Memorandum

4 November 2019

To	Douglas Shire Council and Department of State Development, Manufacturing, Infrastructure and Planning		
From	Sarah Wilson - GHD	Tel	+61 7 5413 8133
Subject	Response to information request from Douglas Shire Council (DSC) and Department of State Development, Manufacturing, Infrastructure and Planning (DSDMIP) Wangetti Trail SP1 - Combined Development Application Response to request for information 1909-13127 SRA	Job no.	4132458

Figure 2 Marine Plant Disturbance

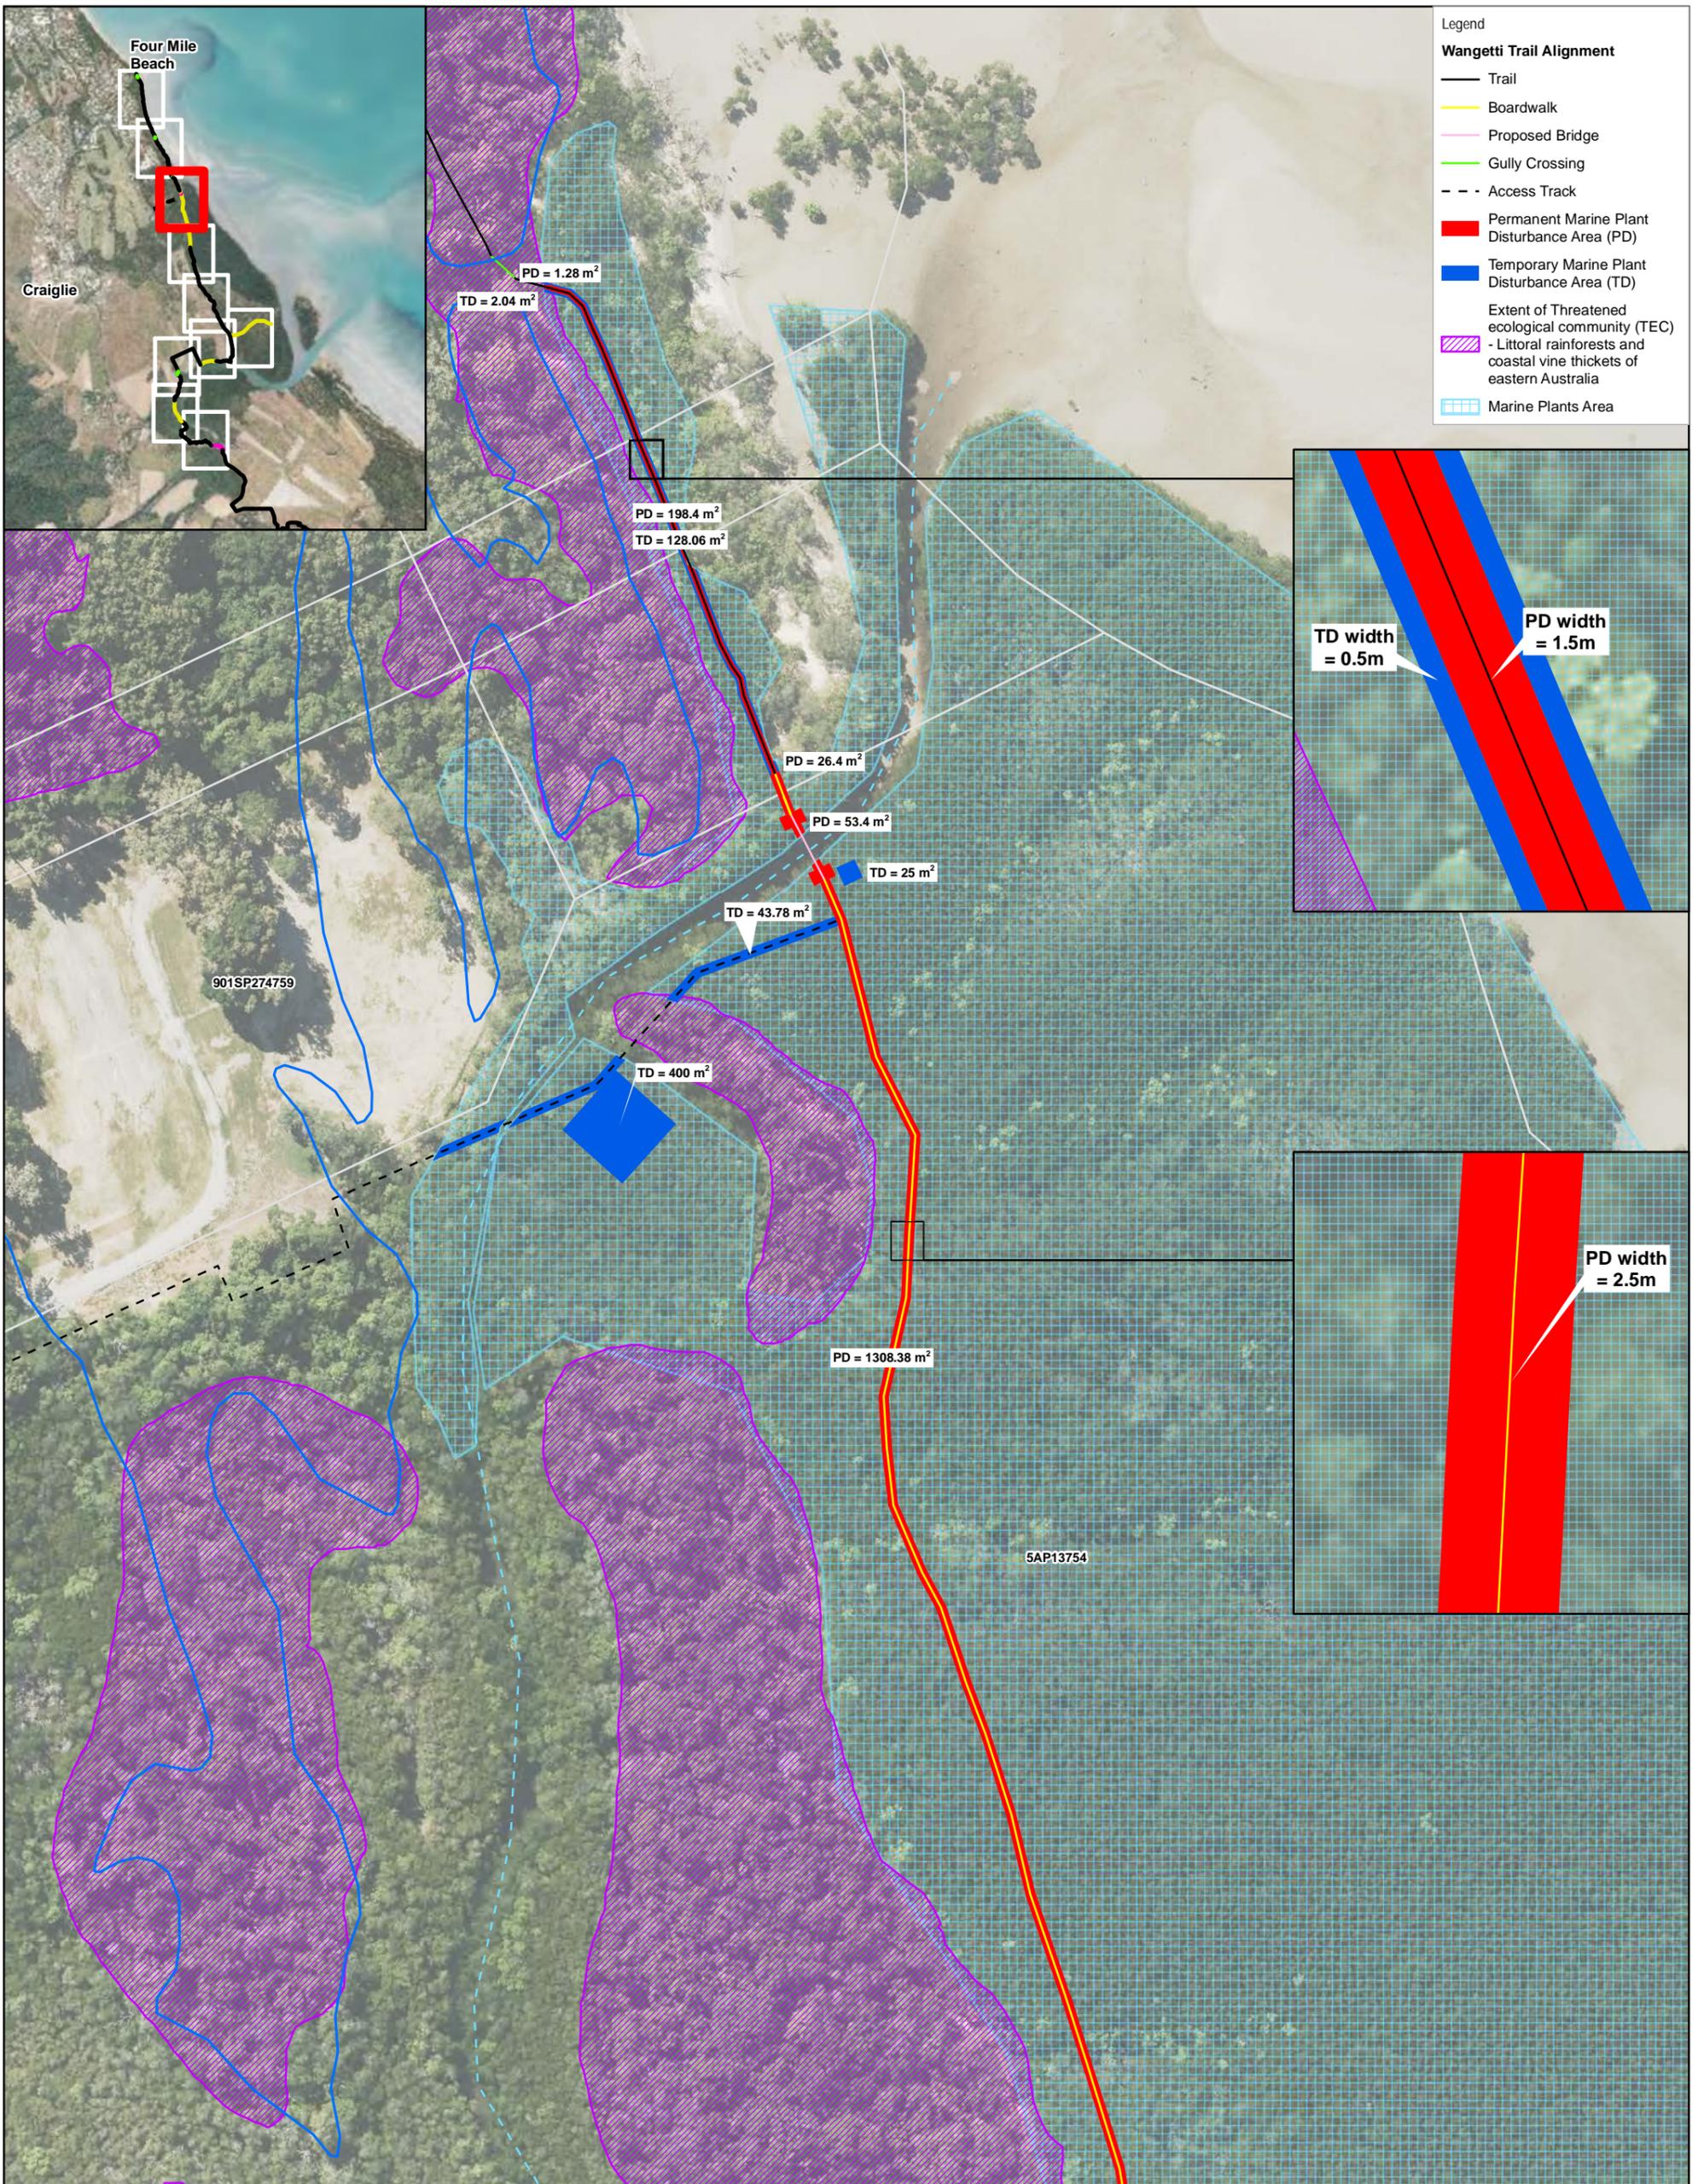
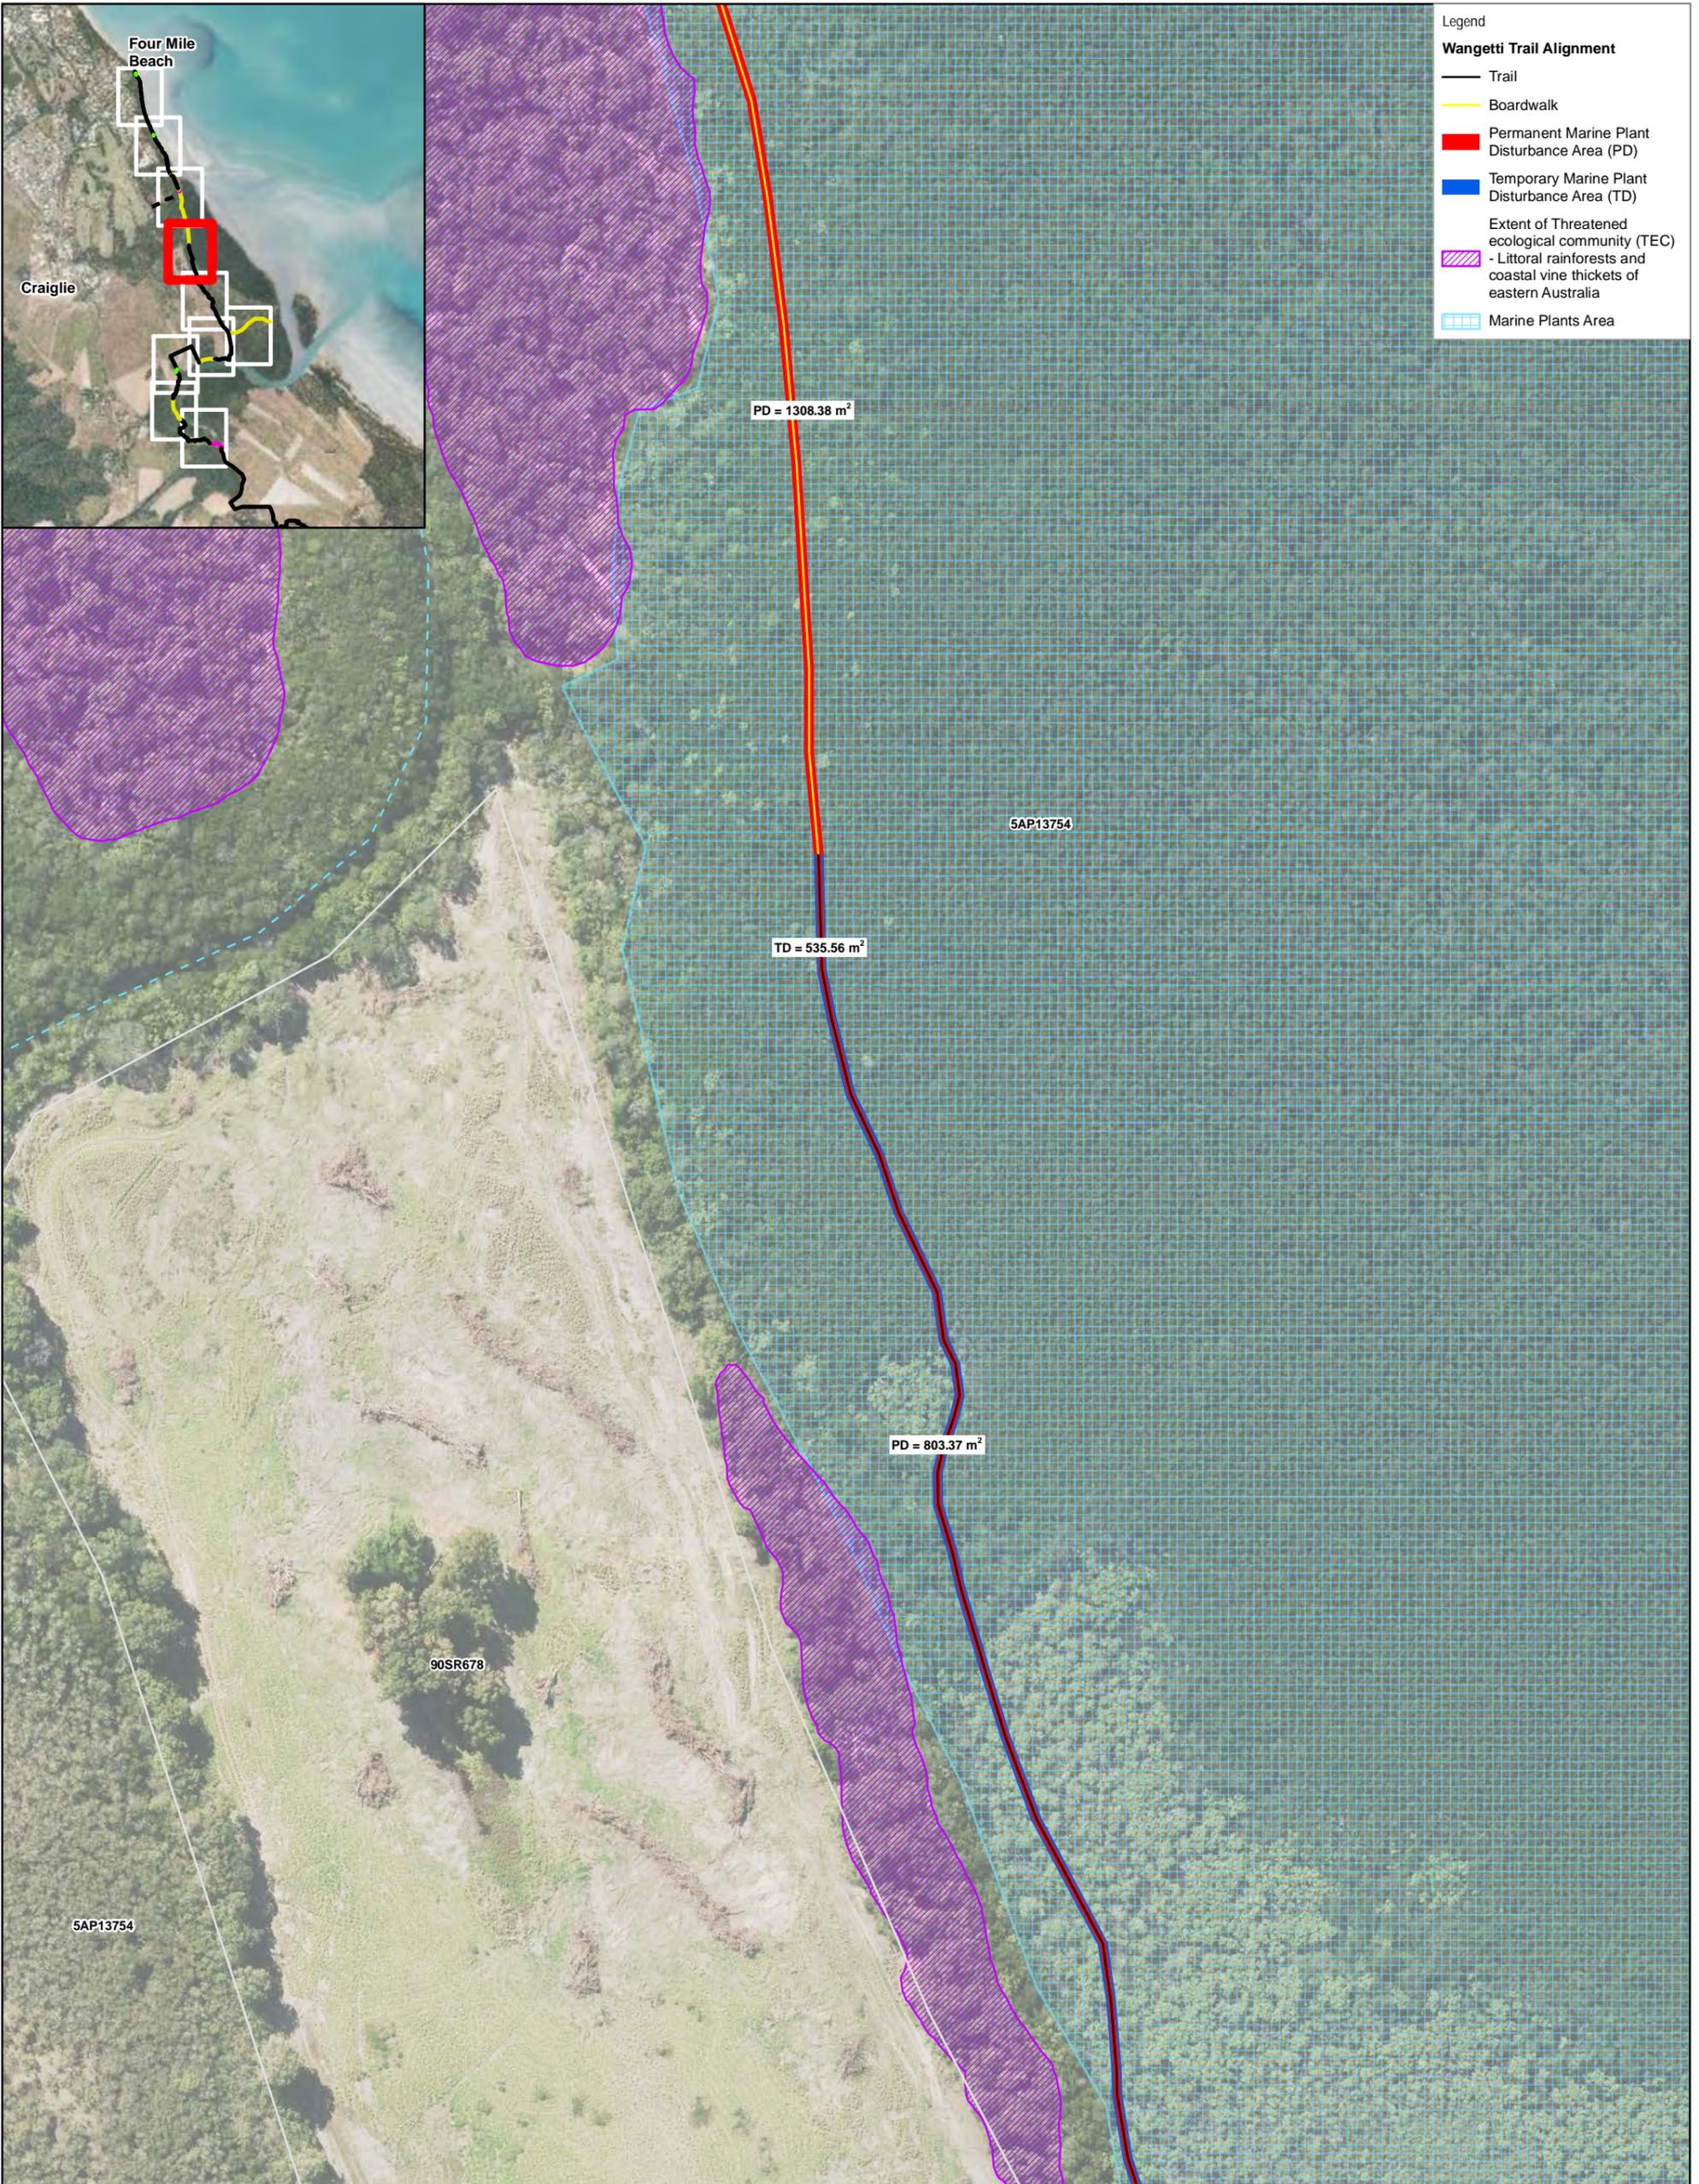
- a) Provide construction plans detailing the location and elevation of the mangrove experience board walk and observation deck.*
- b) Submit scaled drawings of the permanent and temporary disturbance areas for all ancillary infrastructure proposed at Mowbray River location.*
- c) Provide the individual marine plant disturbance area in meters squared (m²) for each works component.*
- d) Provide updated marine plant disturbance areas accounting for high fisheries significant plants.*

Item 3 (c) Provide the individual marine plant disturbance area in meters squared (m²) for each works component.

Figure 2 shows the location of the proposed trail and boardwalk and the location of threatened ecological community (TEC) - Littoral rainforests and coastal vine thickets of eastern Australia. The SP1 alignment has been designed to predominantly avoid areas of TEC, however the trail intersects with a small area of TEC, located approximately 600 m north of the Mowbray River. The TEC was not previously mapped in government databases and was recorded during the site investigation of the area. Based on the composition of the vegetation within the TEC area, it was determined not to contain high fisheries significant plants.

A breakdown of the marine plant disturbance including temporary and permanent disturbance has been provided in Table 3-2 of the Environment Assessment Stage 2 Wangetti Trail Planning Report for Operational Work - SP1 Marine Plant Disturbance Report and is outlined in Table 5 below and shown in Figure 2.
